37/3-93MM 7112 Cedar Avenue
Takoma Park Historic District

Thank you for your letter of March 27th regarding revisions to your approved Historic Area Work Permit (HAWP) for fencing/landscaping at your property at 7112 Cedar Avenue in the Takoma Park Historic District (HPC Case No. 37/3-93MM).

HISTORIC PRESERVATION COMMISSION STAFF REPORT

Address: 7112 Cedar Avenue Meeting Date: 11/17/93
Resource: Takoma Park Historic District Review: HAWP/Alteration
Case Number: 37/3-93MM Tax Credit: No
Public Notice: 11/3/93 Report Date: 11/10/93
Applicant: Warren Fitch Staff: Nancy Witherell
PROPOSAL: Install pool/site alterations/ RECOMMEND: Approve
tree removal

== LOT PLAN ==

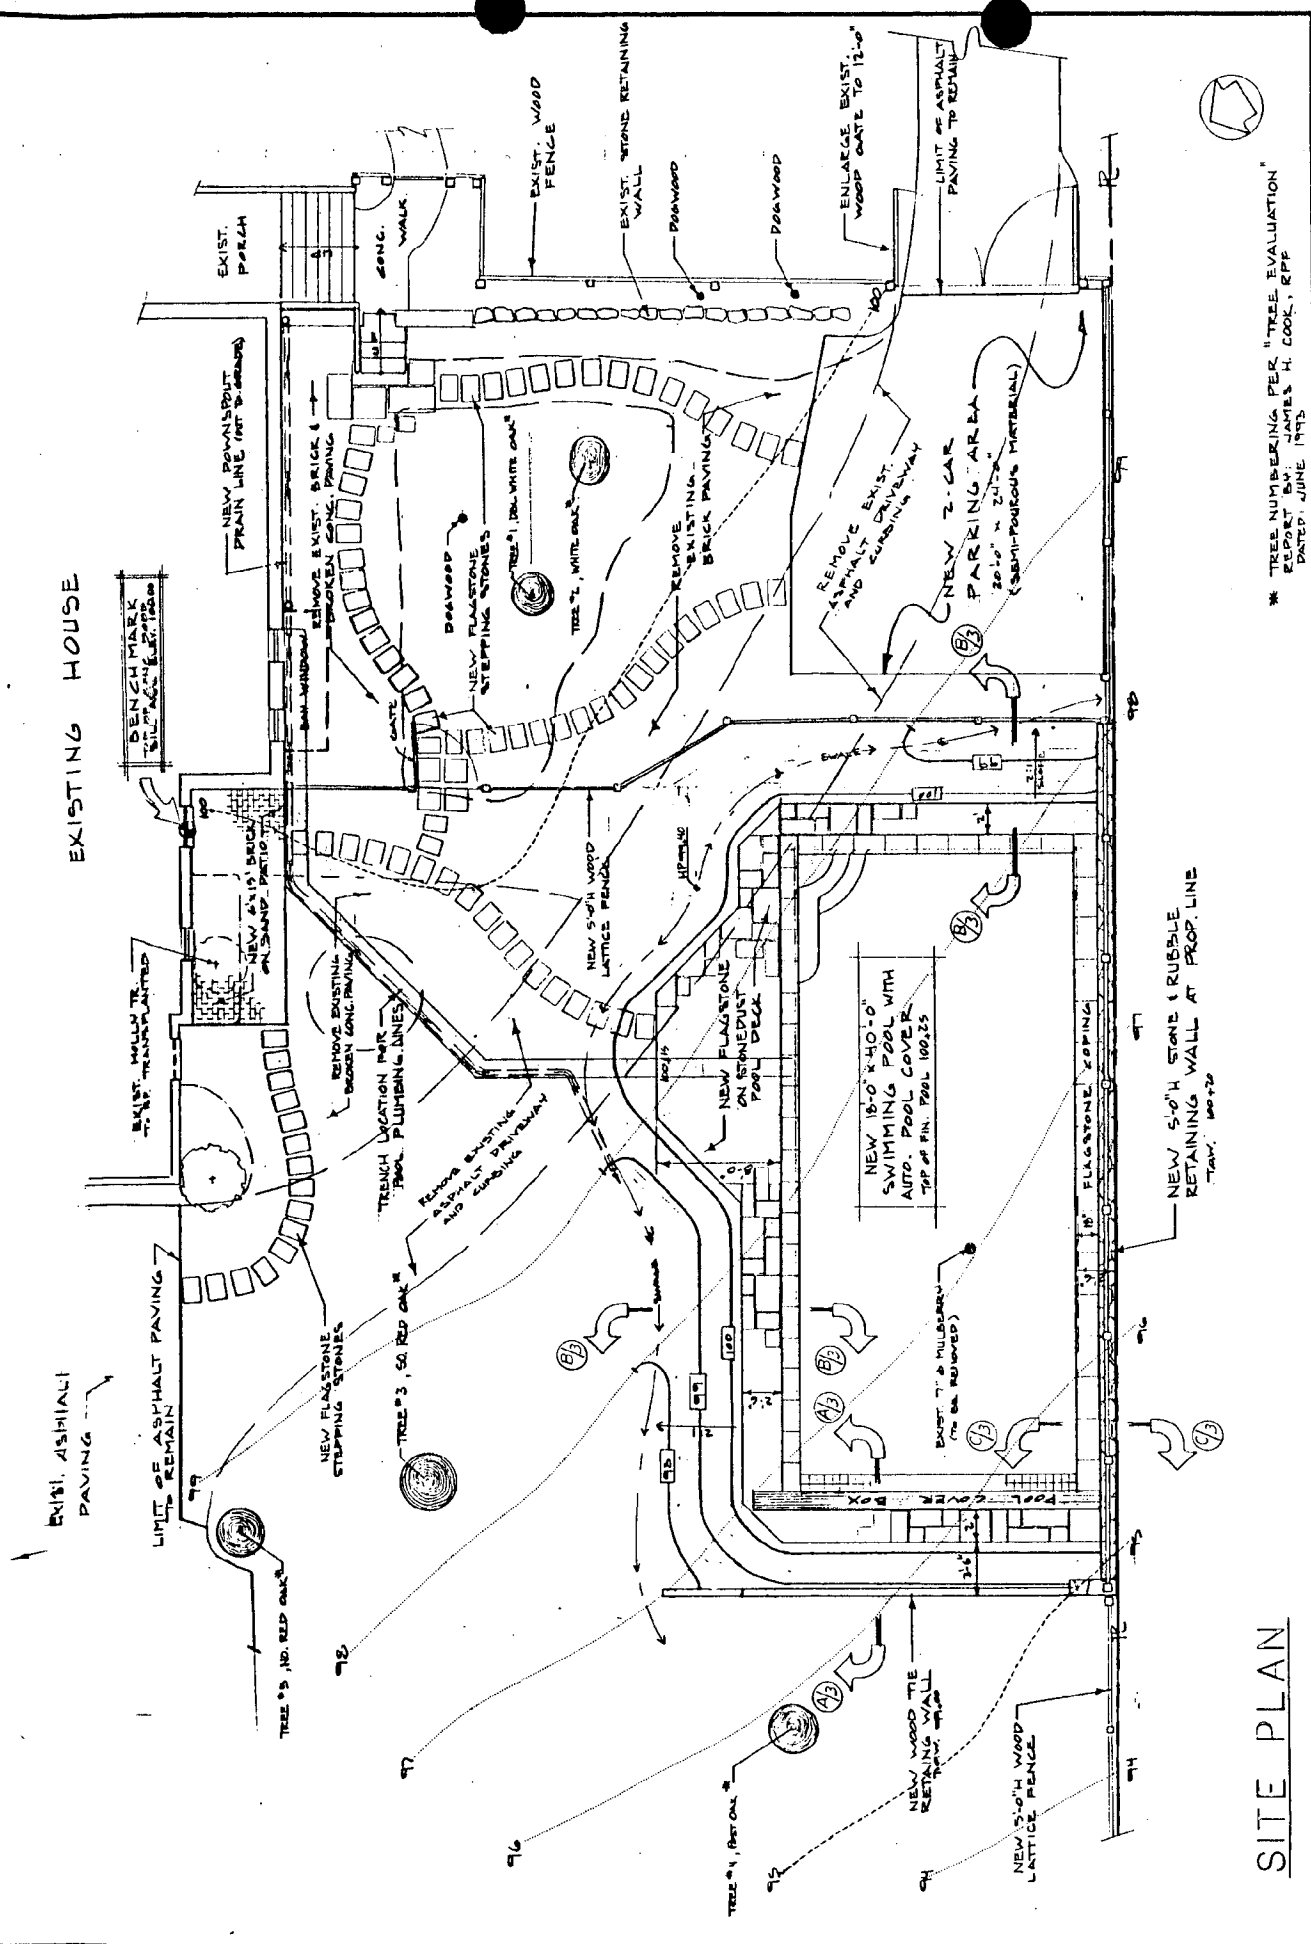
In addition, as required by code, the pool must be surrounded by a 5' high enclosure--in this case a lattice fence at ground level within the property and also along the side property line on top of a stone and rubble retaining wall. Serving as part of the pool wall on the applicants' side of the wall, it would be a retaining wall 5' in height on the adjacent property owner's side. Thus, the height of the enclosure would be 10' in height as seen from the neighbor's yard. The public view would be much more obscured, given the distance from the street, but would still be visible.

The staff's chief concern is with one feature of the project: the 10' height of the wall and fence on the left side property line as seen from the adjacent owner's property--also an outstanding resource. The staff would recommend that the applicants address this issue by installing planting materials on the lower side of the wall (on the adjacent property) if that owner is amenable.

TYPICAL WOOD LATTICE FENCE DETAIL
NOT TO SCALE

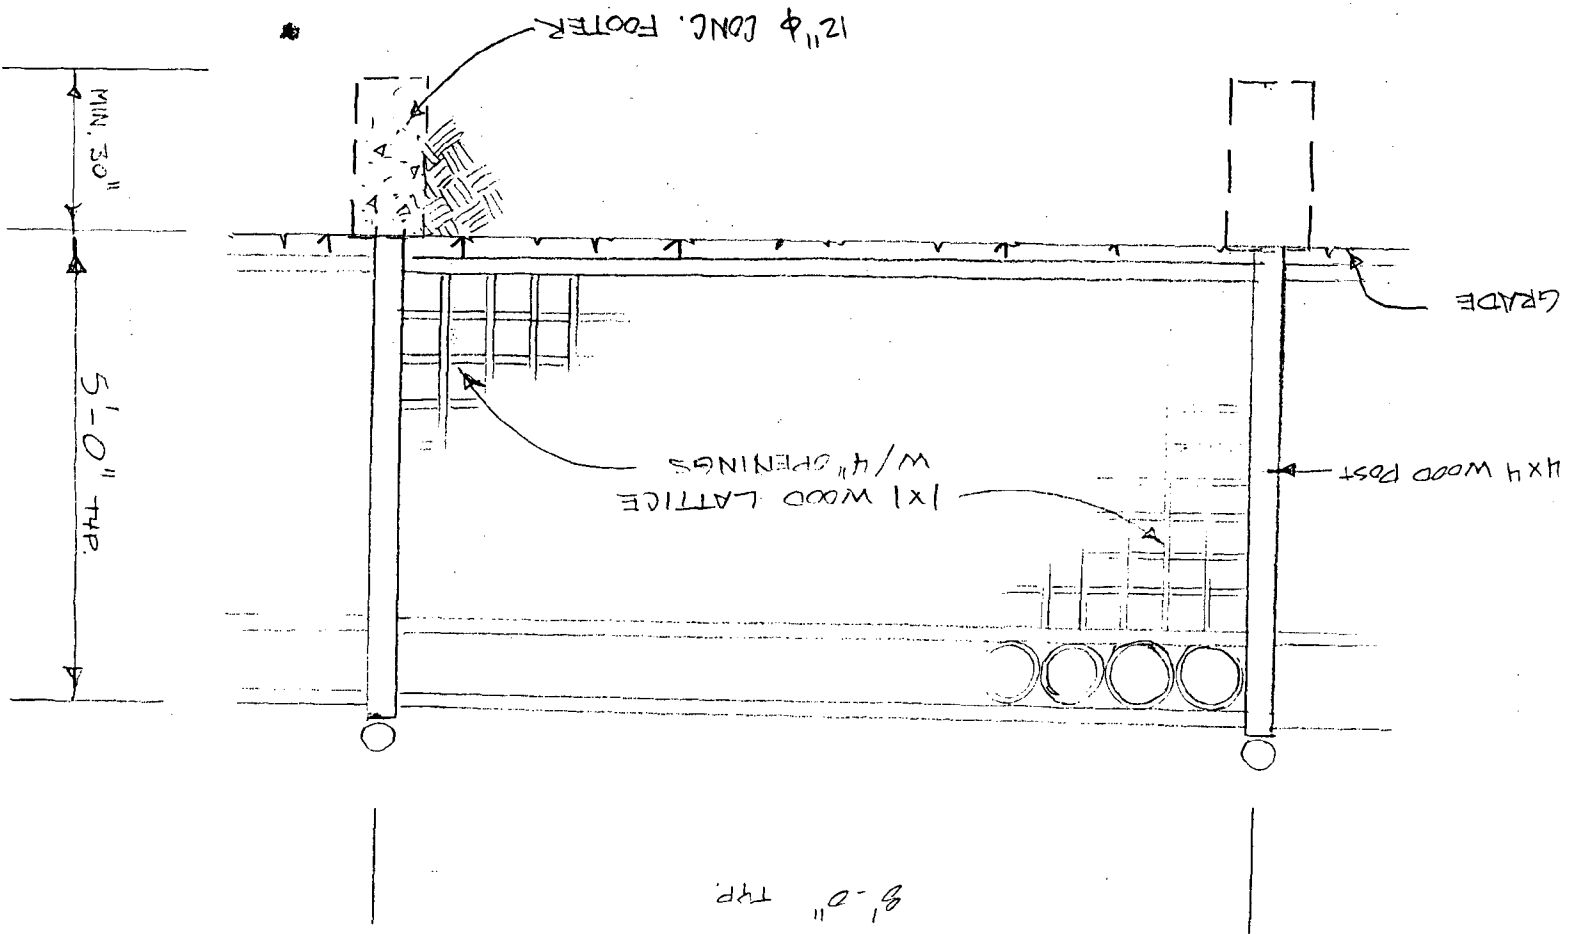
I would note that the HPC's 1993 approval did give you permission to construct a 5' high lattice fence along the southern property line, adjacent to the swimming pool. I understand that you will not be doing that at this time. However, you do have approval for such a fence and will not have to come back before the HPC.
